**Report to
Development Permit Panel**

To: Development Permit Panel
From: Joe Erceg
Manager, Development Applications
Date: January 8, 2002
File: DP 02-208390
Re: Application by Danny Lung for a Development Permit at 7520 Williams Road

That a Development Permit be issued for 7520 Williams Road on a site zoned Comprehensive Development District (CD/124), which would allow the development of four (4) units within two (2) buildings on two (2) lots with a total proposed total building area of 529.800 m² (5,702.91 ft²).

CONTEXT PLAN
NOT TO SCALE

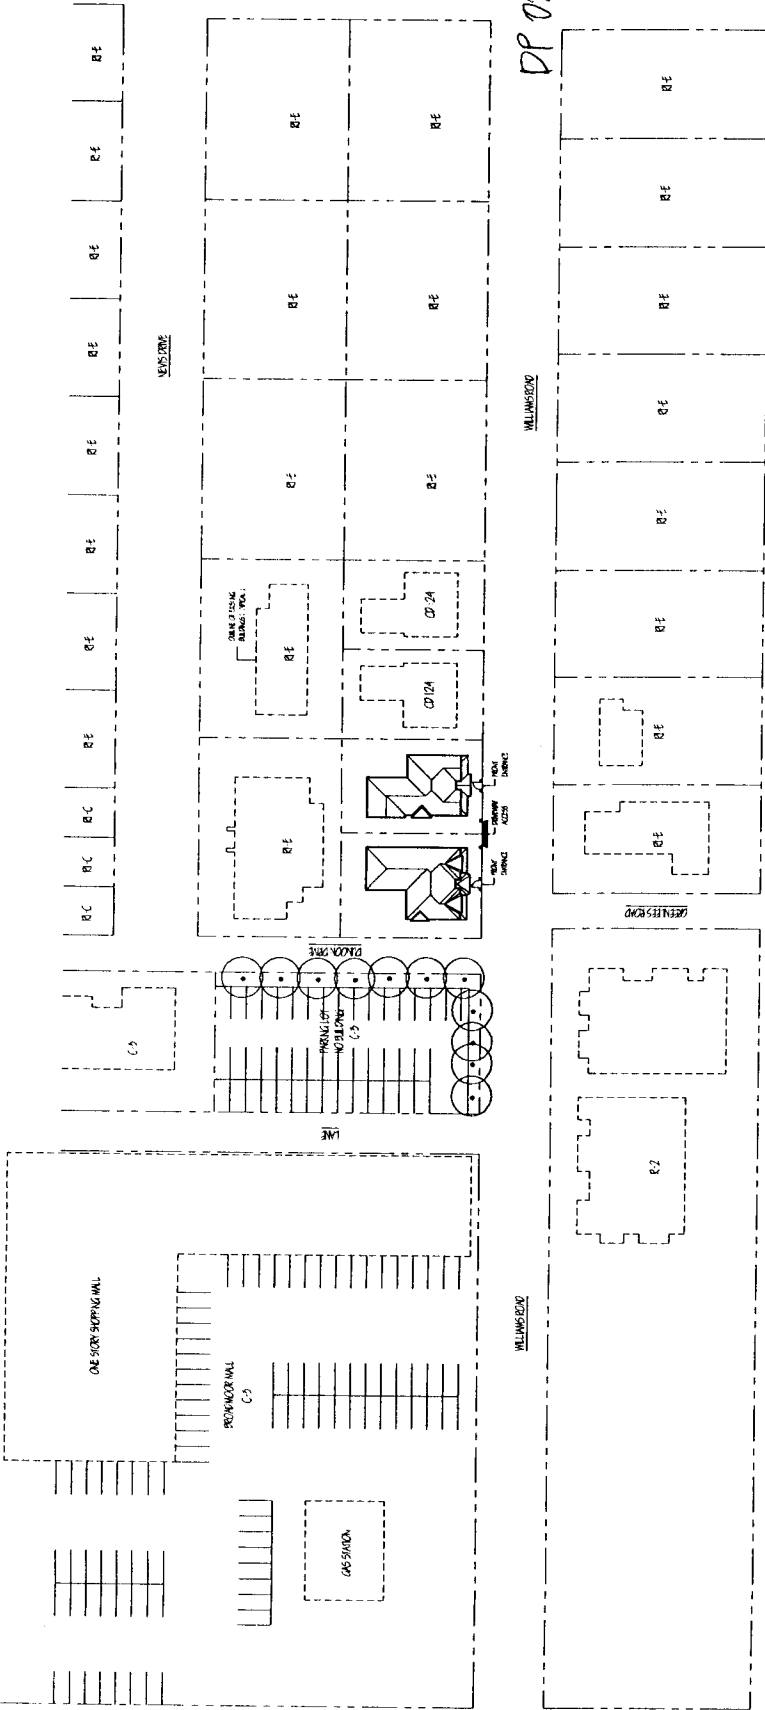
1. Complete the relevant Development Permit Guidelines checklist. ***The applicant has complied.***
2. Provide a context plan, which indicates exiting land use and zoning for a minimum of 100 m (±300 ft.) in all directions surrounding the subject site. Indicate the approximate, existing layout of existing residential buildings to the south of the subject site that front on Nevis Drive. Show the building layout and vehicle circulation and parking pattern for the Broadmoor commercial area across Dunoon Drive. ***The applicant has complied.***

SITE SECTION, SOUTH OF THE SUBJECT SITE
1/8" = 1'-0"

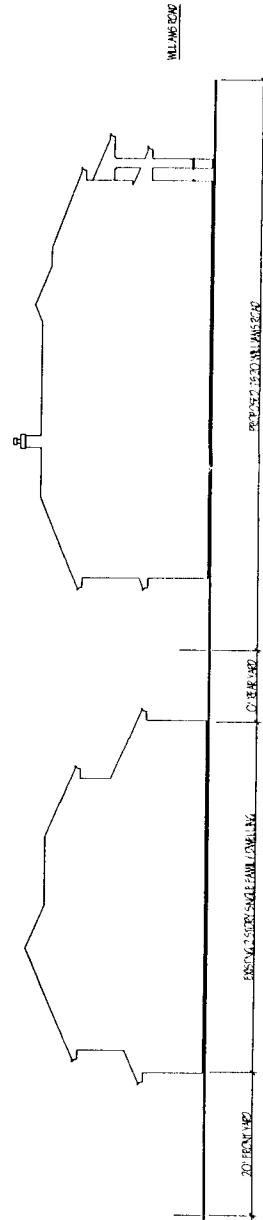
3. Provide site sections that extend to the single-family dwellings south of the subject site. ***The applicant has complied.***
4. Provide a total site summary of relevant statistics including the proposed building area, density in dwelling units per acre, site coverage, floor area ratio and parking as well as a detailed summary of floor space for each proposed building. ***The applicant has complied.***

NORTH ELEVATION (VIEW FROM WILLIAMS ROAD)

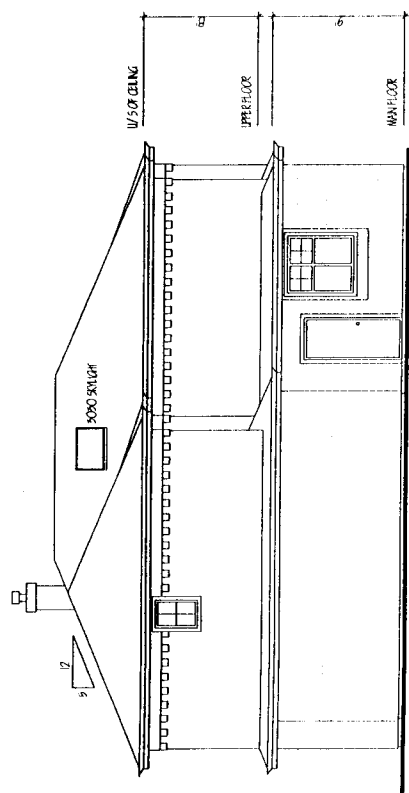
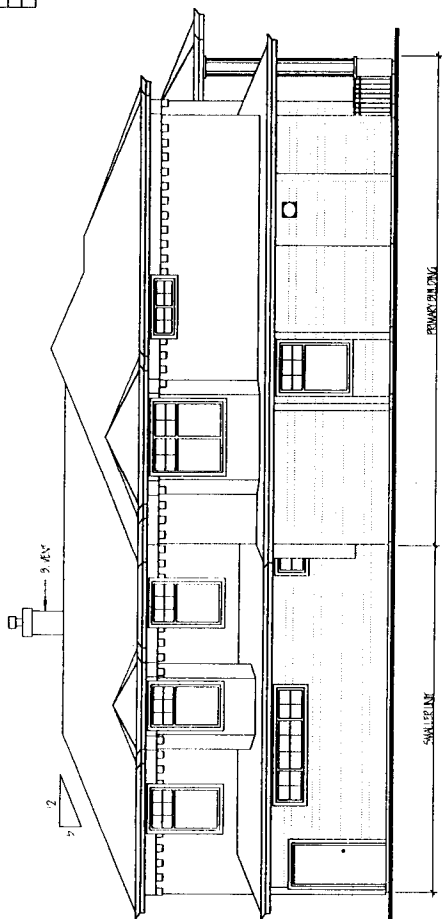
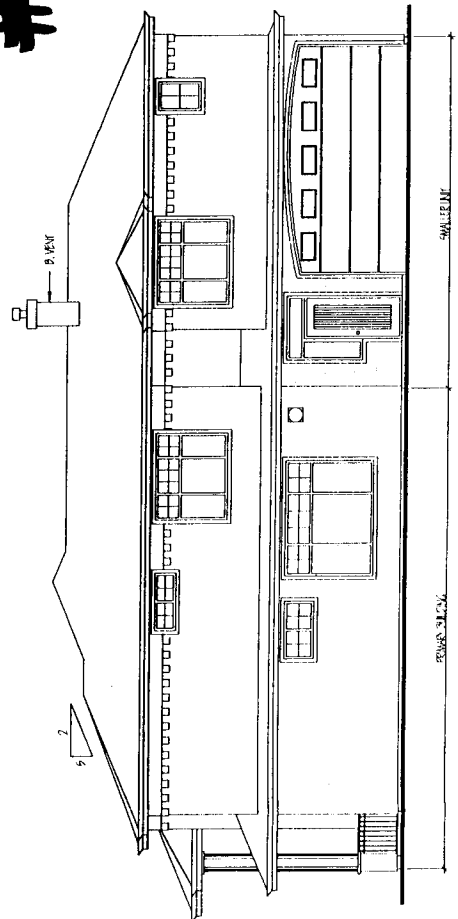
6. Clarify if a porch is proposed along Williams Road. ***A porch is proposed on one building that is proposed to front on Williams Road.***
7. Vary the front facade design of these two units. There should be considerable variety for the building elevations that will front Williams Road. ***The applicant has complied.***

8. Create a well-articulated and fine-grained architectural design for each building and ensure that the quality of façade design and materials is reflected on all four elevations of each building. Consider facade articulations to any long straight building walls. ***The applicant has complied.***

9. Provide building elevations for all four sides of each building and continuous building elevations for all four sides of the subject lot. ***The applicant has complied.***

Site GRADING PLAN
Date: 199.2007
Sheet: 1 of 1
Scale: 1" = 10'

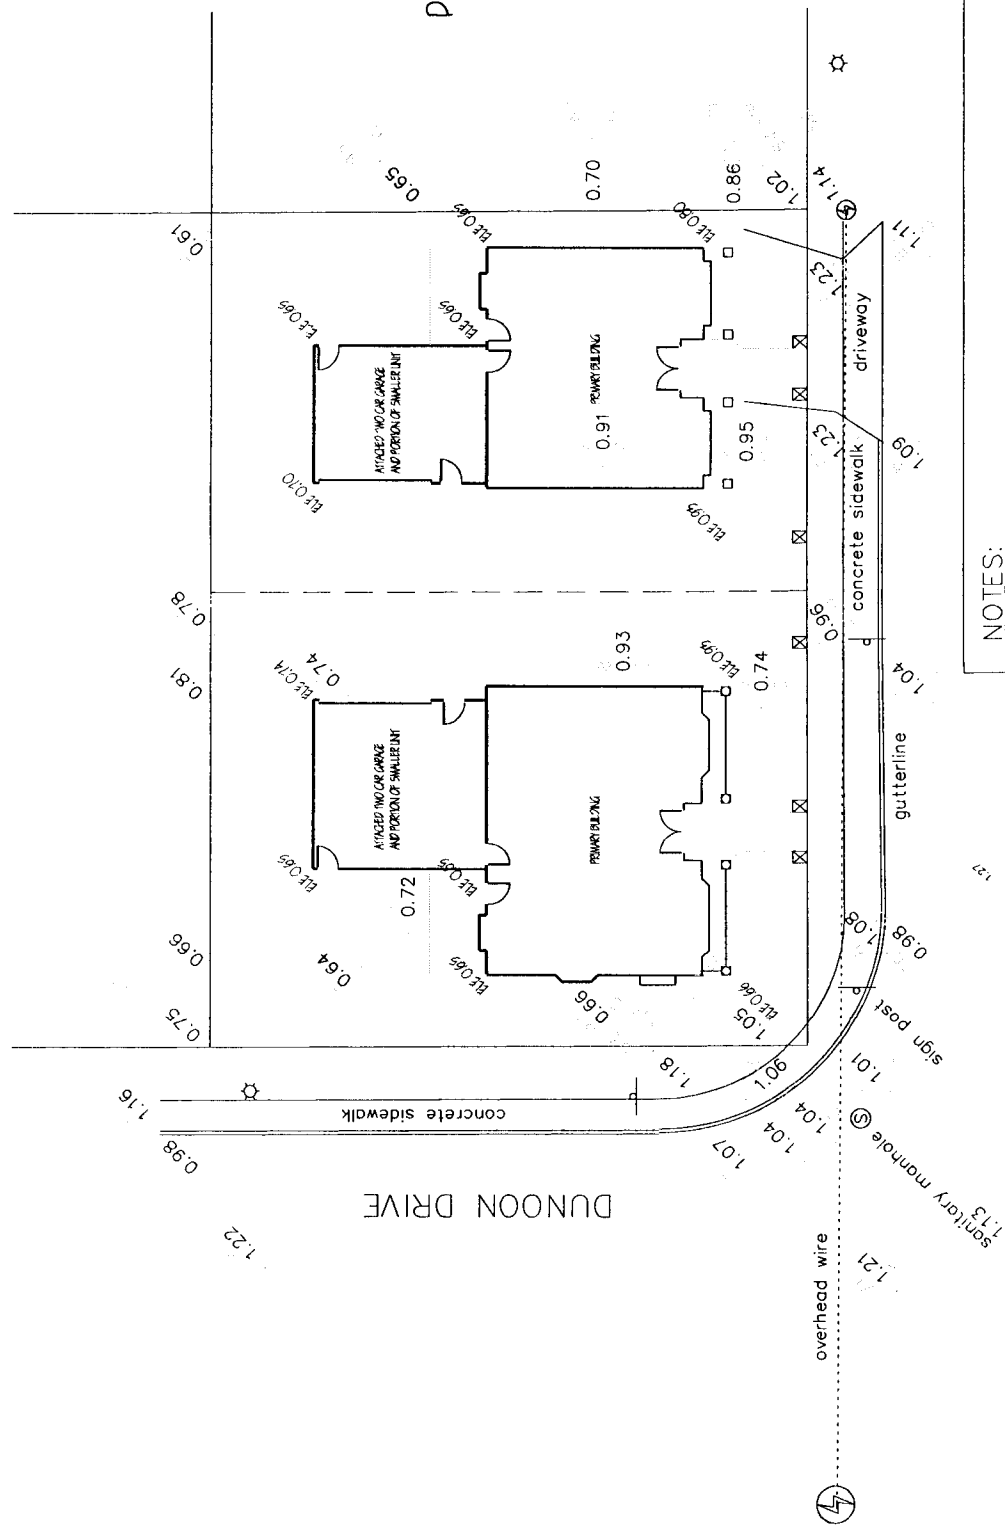
20. Show conceptual lot grading and drainage including existing and proposed elevations at critical locations along the property lines. ***The applicant has complied.***
